## **GARD response to Thames Water’s April 2017 Fine Screening Report**

This paper gives GARD's comments on Thames Water's up-dated Fine Screening Report dated April 2017. In general, we feel that the detailed comments that we made on the October 2016 Fine Screening Report<sup>1</sup> have been either unjustifiably rejected or ignored altogether. This response is brief of necessity, bearing in mind the short time available to make it and the ever-increasing tightness of the WRMP programme. Where possible, we have referred back to our October 2016 FSR response and other recent GARD papers, rather than repeat the same arguments in full.

Figure 1 - TW forecast of growth in water supply deficit for London

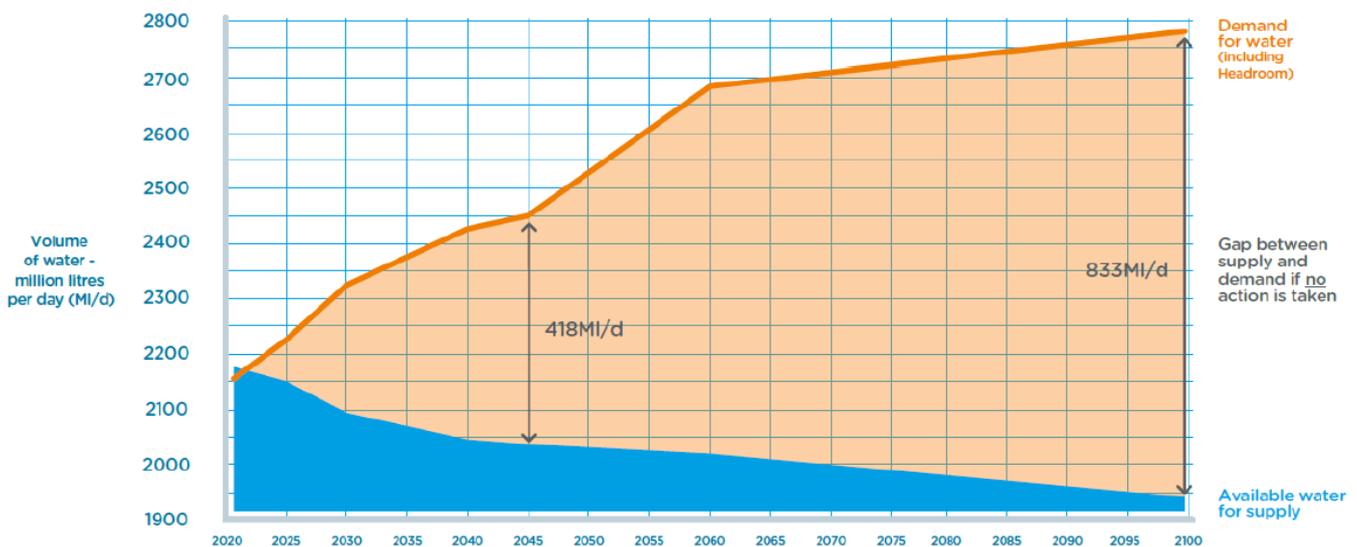
This raises a number of questions:

1. Demand is forecast to rise by about 630 MI/d between 2020 and 2100, an increase of 30%. This increase is net of reductions due to improved demand management and leakage control, so the underlying demand increase is substantially higher than 30%. This is a very large increase and no justification has been supplied. Slide 7 states that these demand increases have been determined by Edge Analytics and Leeds University. Please can full details of this be made available to stakeholders?
2. Demand is shown to rise sharply between 2045 and 2060. On querying this at the stakeholder meeting on 28<sup>th</sup> April, we were told that this is due to increased immigration.

What is the justification for this? Why should immigration suddenly increase in 2045? How can this be reliably forecast more than 25 years into the future? Does this estimate take account of the immigration controls that seem likely post-Brexit?

3. Available supply is shown to fall substantially between 2020 and 2040:

- 75 MI/d between now and 2030
- 60 MI/d between 2030 and 2040

What is the explanation and justification for these falls in supply output?

4. Slide 8 of the stakeholder presentation showed a sustainability reduction of 125 MI/d for the Lower Lee licence. At the meeting we were told that this is in addition to the reductions in supply shown in Figure 1 above. What is the justification for this reduction? Please can we see the Environment Agency's report on this?

5. Between 2040 and 2100, available supplies are shown to fall by a further 100 MI/d, ie 5%. No explanation is offered, but we assume that this is to allow for the possible effects of climate change. Whilst accepting that it makes sense to make contingency plans for the possibility of reductions in supply due to climate change, we would comment that these reductions are highly uncertain.

**Figure 2 - Frequency and severity of droughts affecting London's water supplies**

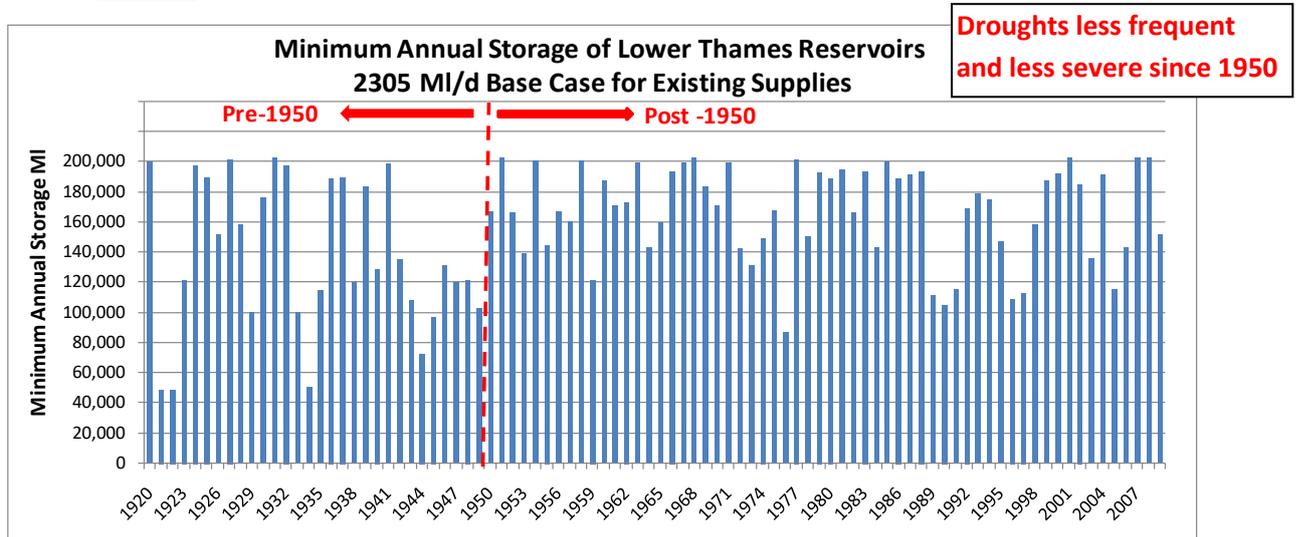
This plot shows the WARMS2 minimum annual storages from simulation of existing London's supplies at the base case maximum output of 2305 MI/d, under the historic flows since 1920. From visual inspection of the plot, it is clear that that the effects of droughts have become less frequent and less severe since about 1950. In our opinion, this is strong evidence that London's supplies have not become more vulnerable to droughts over the past 100 years, despite the climate change that has already occurred.

We accept that this should not be used as evidence that climate change will not make London’s supplies more vulnerable to droughts in the future – there are no grounds for complacency. However, it puts the likelihood of this happening into perspective – the climate change impacts are highly uncertain. Equally, in our opinion, there are big uncertainties associated with the demand growth shown in Figure 1 above.

**Figure 3 - TW forecast of growth in deficit for Swindon and Oxford zone**

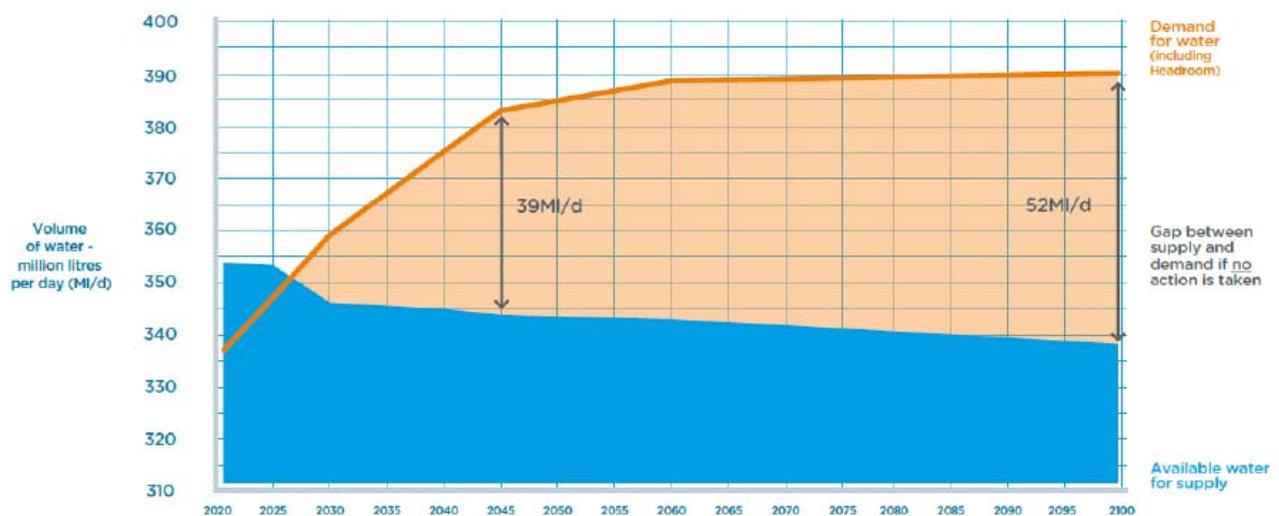
As for London, the Fine Screening Report should include an explanation and justification for the deficits, include details of the uncertainties associated with the forecast and an assessment of the likelihood of the deficit occurring. Also as for London, there should be a ‘no regrets’ approach to resource development and measures for the suitability of the supply options in achieving this, recognising the uncertainties in growth in demand and reduction in water available.

**Figure 4 - TW latest forecast of growth in deficit for Slough, Wycombe and Aylesbury zone**

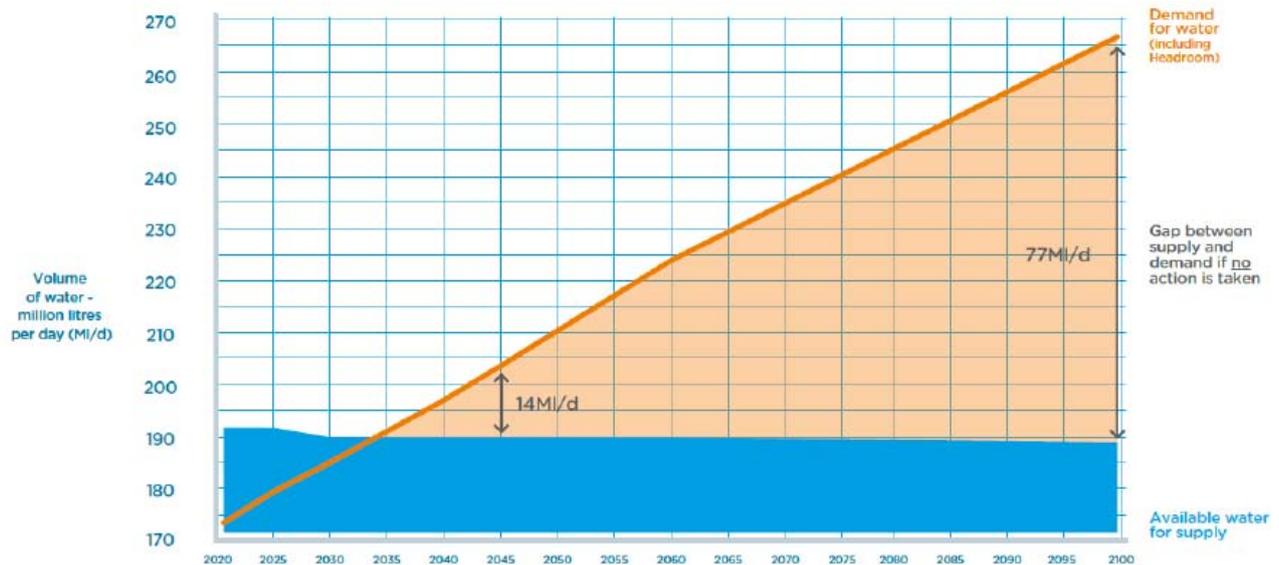
The Fine Screening report offers no explanation or justification for the very large increase in demand in Thames Water's forecast. The forecast 77 MI/d deficit in 2100 is orders of magnitude bigger than the 6 MI/d deficit in 2040, as forecast in WRMP14. This has shifted the measures required from being minor adjustments to existing sources to the need for major development. The absence of highlighting of this in the Fine Screening Report is a serious lapse in transparency, which should be rectified.

As far as we can see, Section 7 of the Fine Screening Report contains no proposals for meeting a 77 MI/d deficit. Is this to be another attempt to justify the Abingdon reservoir? The options for meeting a deficit of this magnitude should be made clear in the Fine Screening Report.
